Studebaker

SERVICE BULLETIN

NO. 255

1951

ABOVE: NEW SPARK ADVANCE CURVE (AFTER ENGINE No. V-99953, COMMANDER V-8).

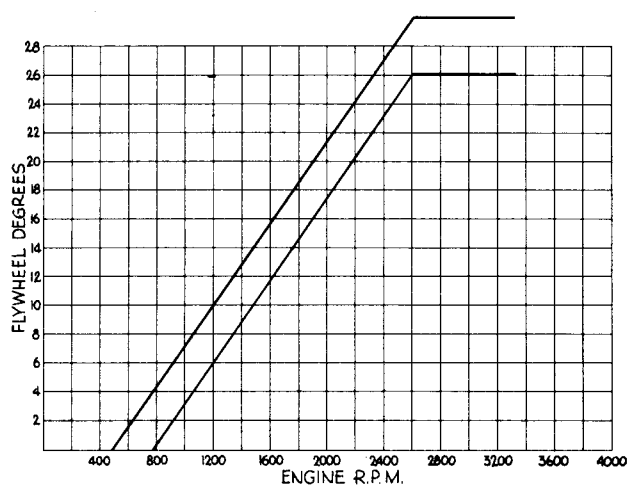
Effective with 1951 Commander Model Engine No. V-99954, new distributor governor weight springs entered production. This has resulted in a change in the part number of the distributor-and-spark modifier assembly, which, effective with Engine No. V-99954, is Part No. 531804 (Model No. 1110826).

The new governor weight springs are Part No. 531759 and will be sold in sets of two springs to the set. The new type of springs is fully interchangeable with the old as sets in service.

The purpose of this change in the governor weight springs is to give a slightly slower centrifugal advance in the low speed ranges, so that the spark advance curve more closely conforms to the requirements of the lower octane fuels generally available today. (See curve illustrated at top of page and compare with curve at left, which is taken from p. 23 of the Electrical Section of your 1951 Passenger Car Shop Manual.) There is no change in the vacuum advance characteristics.

It is important when testing 1951 Commander V-8 engines to know the model number of the distributor in the car. If the model number is 1110822, check against the curve shown at left or in the Shop Manual; if the model number is 1110826, check against the spark advance curve shown at the top of this page.

CHANGES IN HYDRAULIC BRAKE BOOSTER PISTON PUSH ROD SEAL (BENDIX).

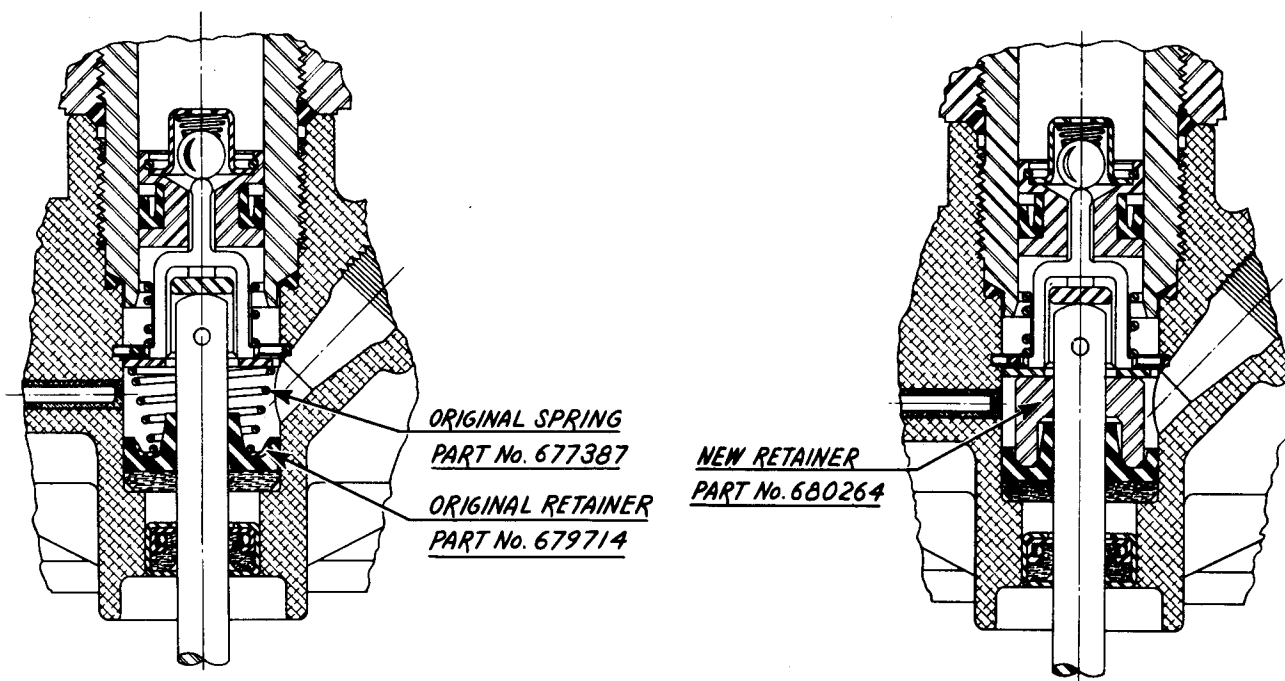
The drawing below illustrates the new push rod seal retainer, Part No. 680264, which has replaced the former type of retainer and spring, Part Nos. 679714 and 677387, respectively.

The new one-piece retainer can be installed in service in place of the original type spring-and-retainer arrangement. When present parts stocks of original type parts are depleted, the new type retainer, Part No. 680264, will be furnished in filling orders for Part Nos. 679714 and 677387.
